Amendments to the Drawings

Appl. No. 10/608,684

Amdt. A dated December 9, 2004

Reply to O.A. of September 9, 2004

FIG. 2

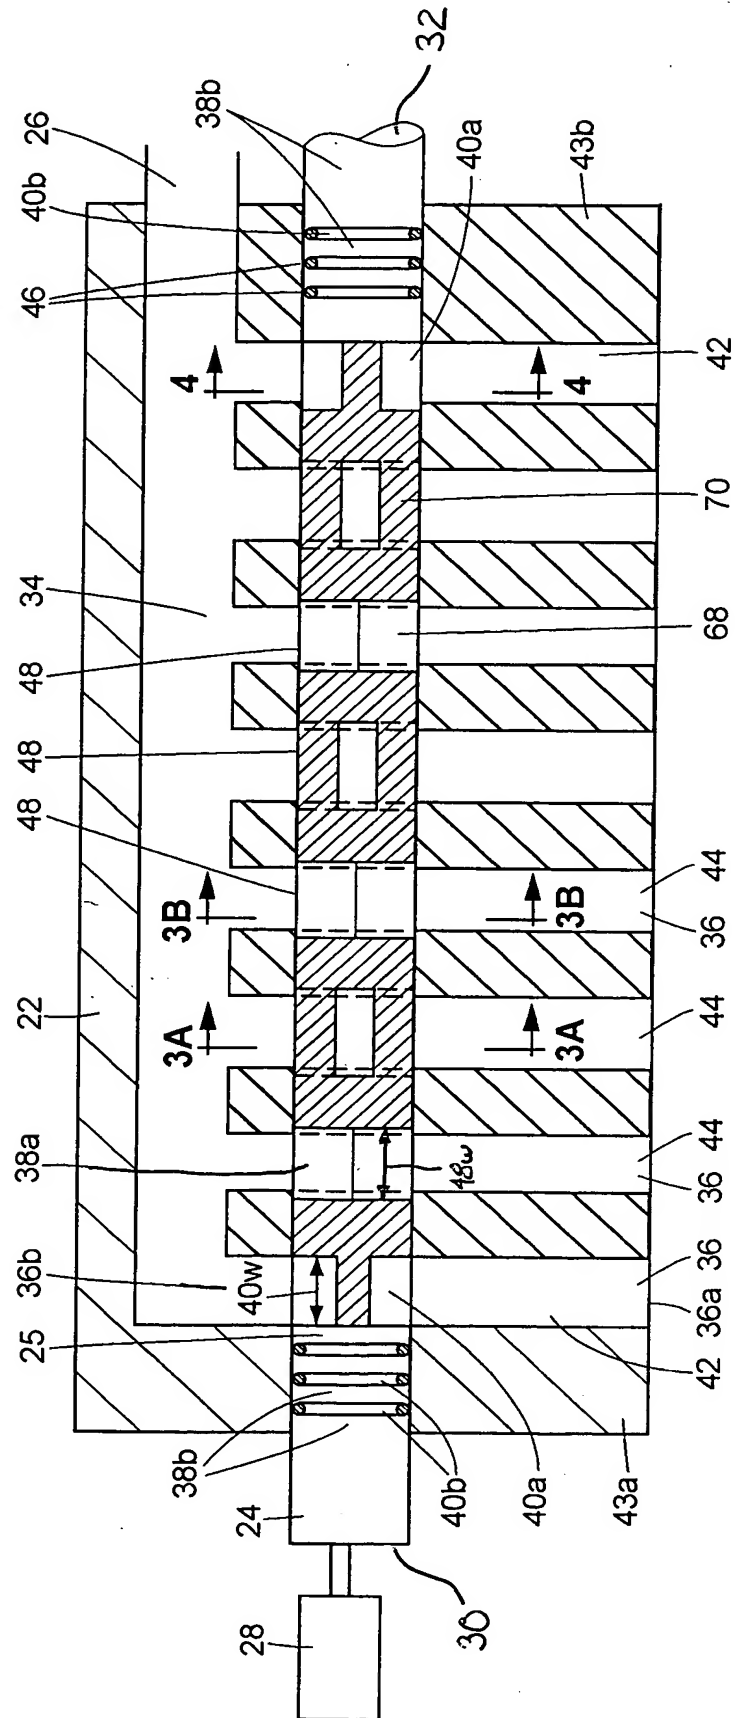
In Figure 2, reference numbers 30 and 32, with appropriate lead lines indicating the opposite ends of the valve element, and reference number 48w and dimension indicator, with an appropriate lead line indicating the width dimension of the apertured sections, have been added in accordance with the usage thereof in the original specification:

The remaining amendments to Figure 2 (extending the lead lines of reference numerals 36b and 38a) and Figure 3B (changing reference numeral 50a to 50c) correct inadvertent differences between the drawings as originally filed and the formal drawings filed on July 14, 2004. These amendments do not add new matter or present a change from the drawings as originally filed. Therefore, the undersigned respectfully requests the examiner to enter these amendments to the formal drawings.
